IN THE DRAWINGS:

REMARKS

~~FIG.5~~

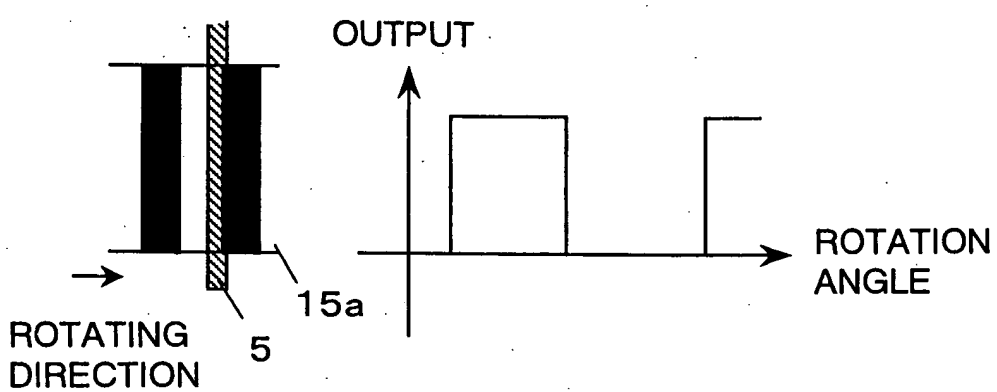
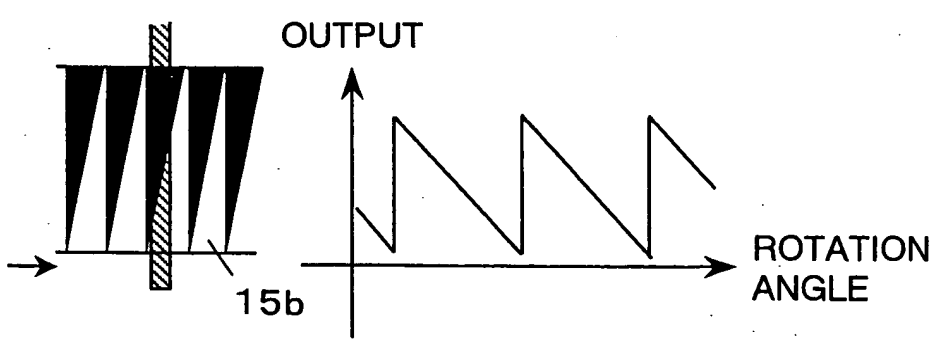
FIG.5 (A)

FIG.5(B)

~~FIG. 8~~

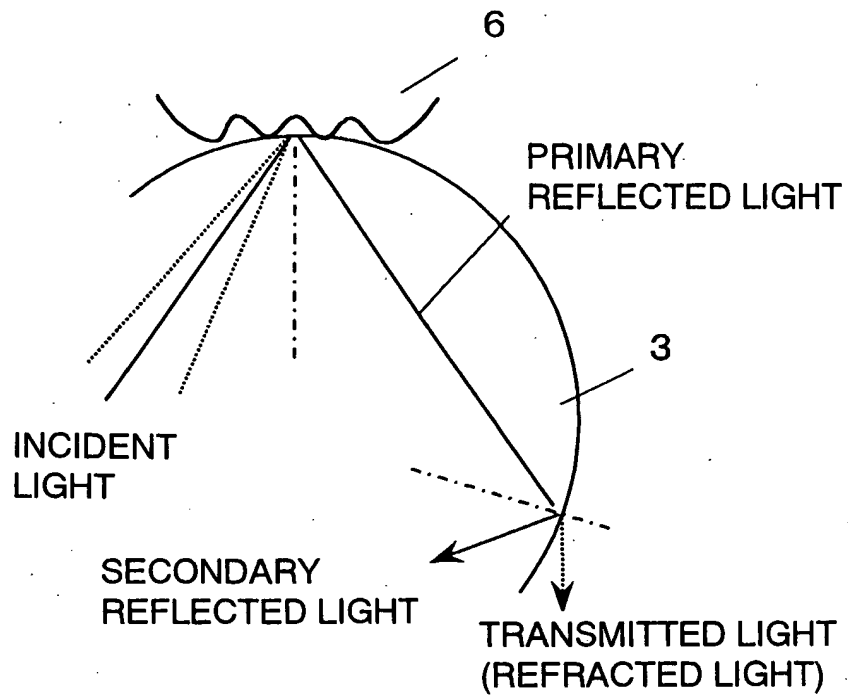
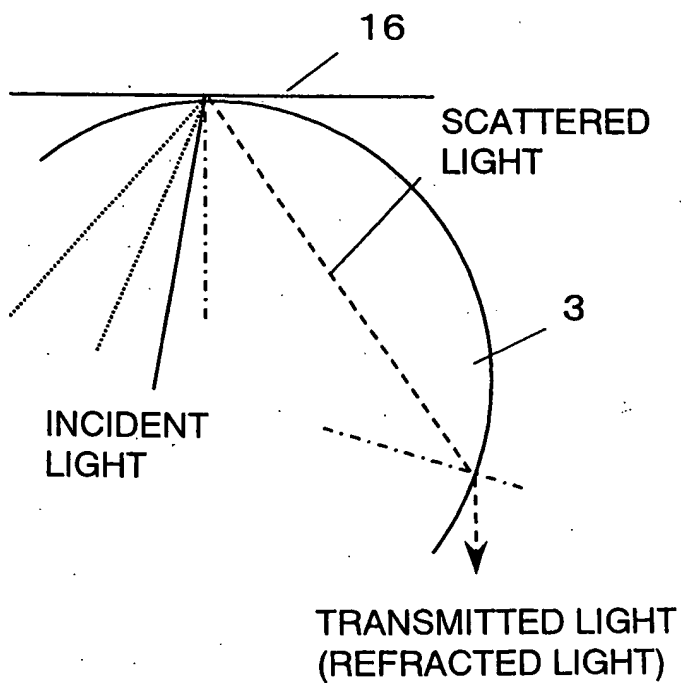
FIG. 8(A)

FIG. 8(B)

~~FIG. 9~~

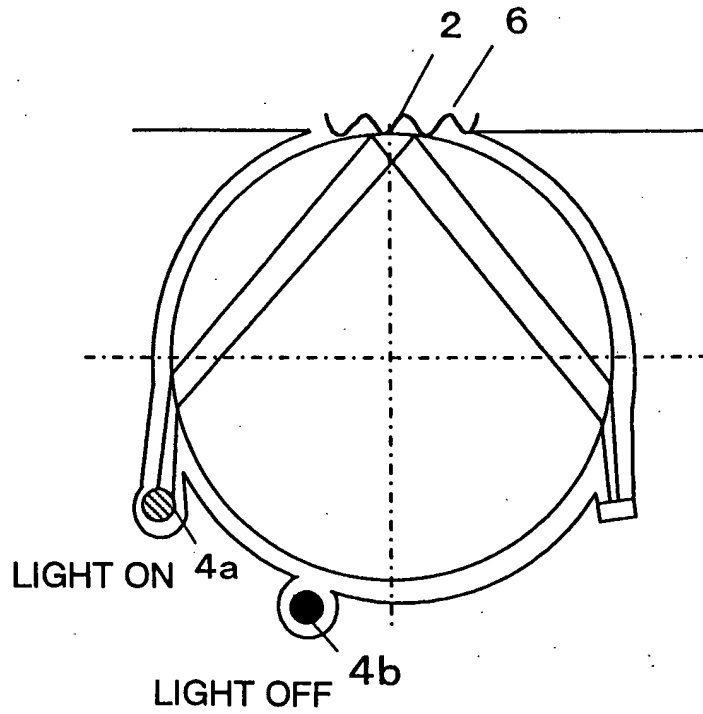
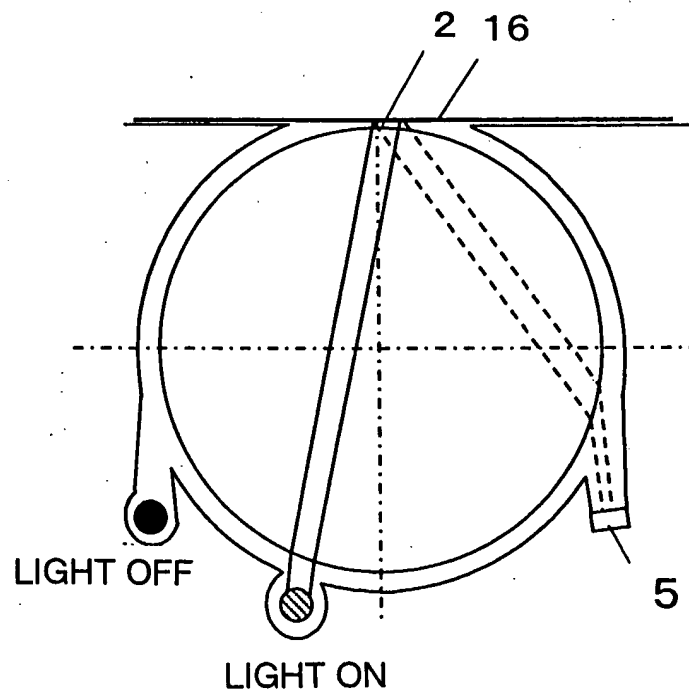
FIG. 9(A)

FIG. 9(B)

~~FIG. 10~~

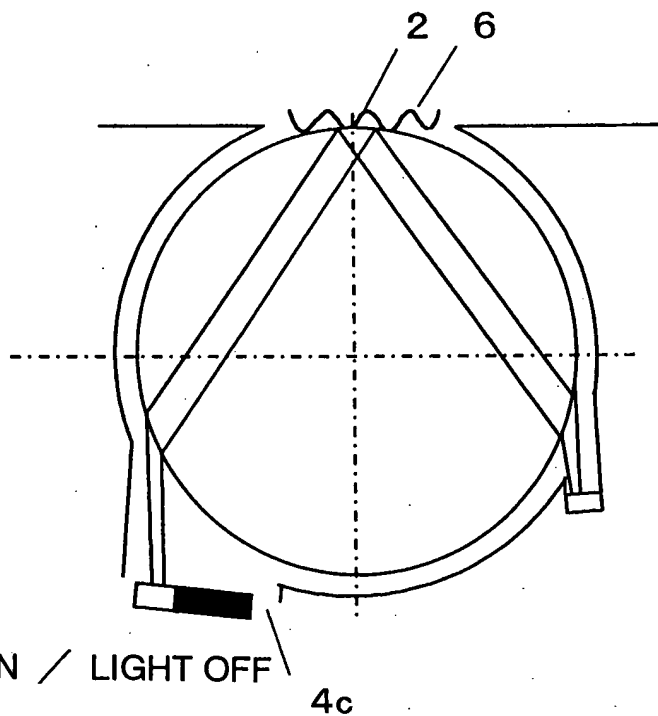
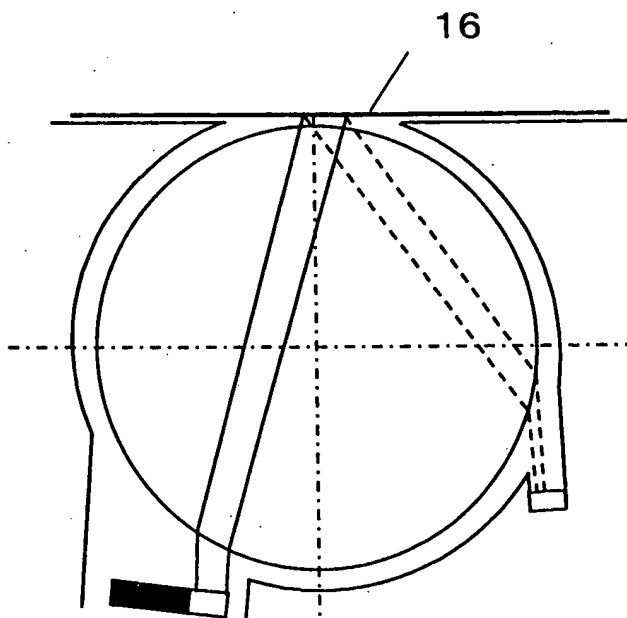
FIG. 10(A)

FIG. 10(B)

~~FIG. 11~~

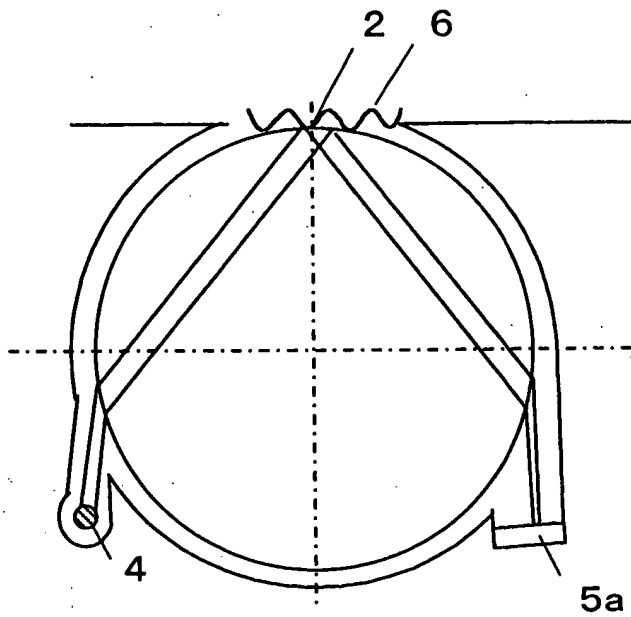
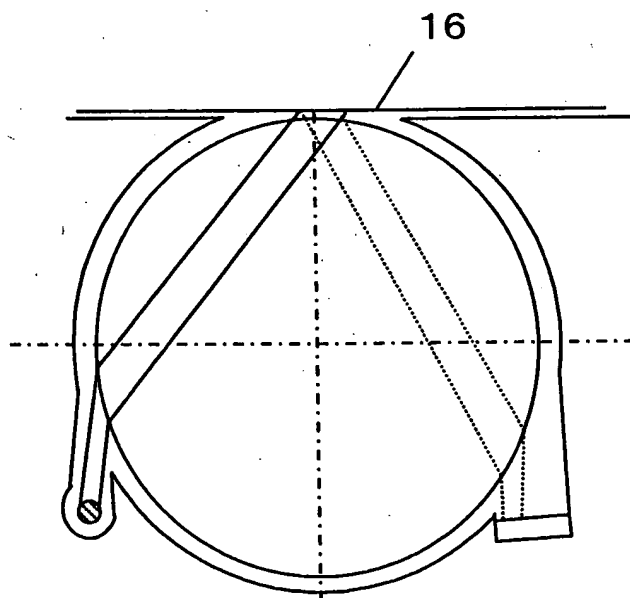
FIG. 11 (A)

FIG. 11 (B)

~~FIG. 12~~

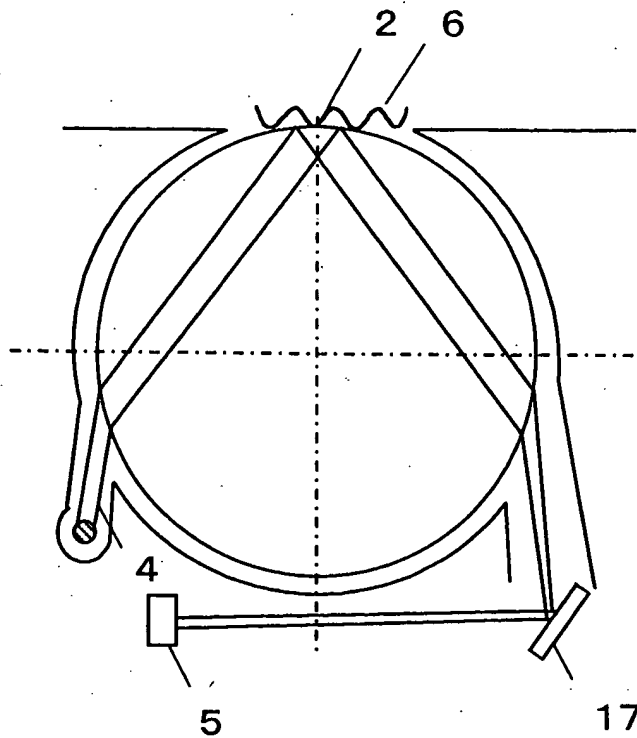
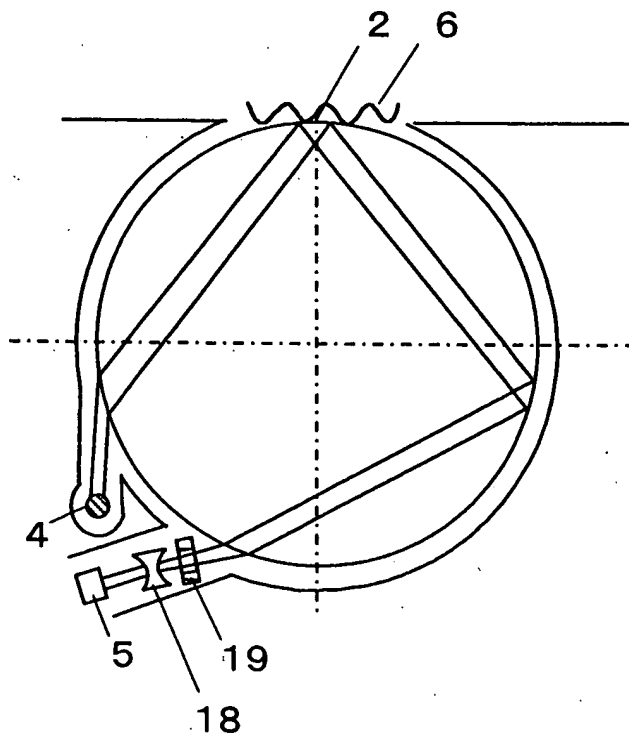
FIG. 12 (A)

FIG. 12 (B)

~~FIG. 16~~

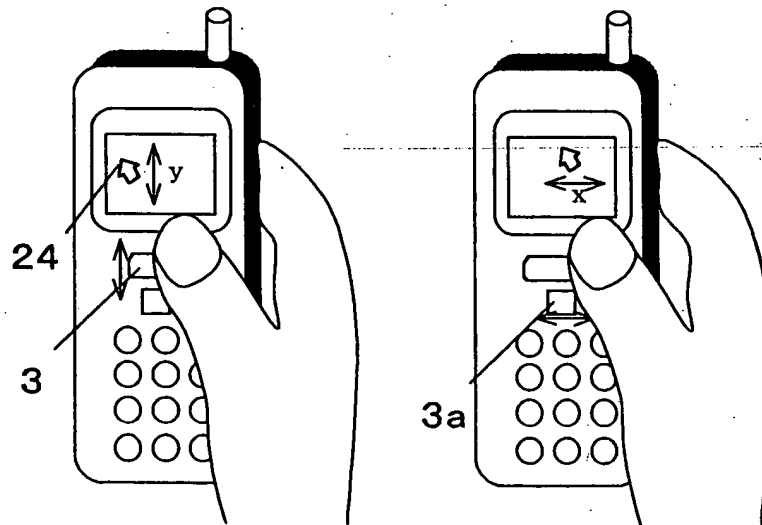
FIG. 16 (A)

FIG. 16 (B)
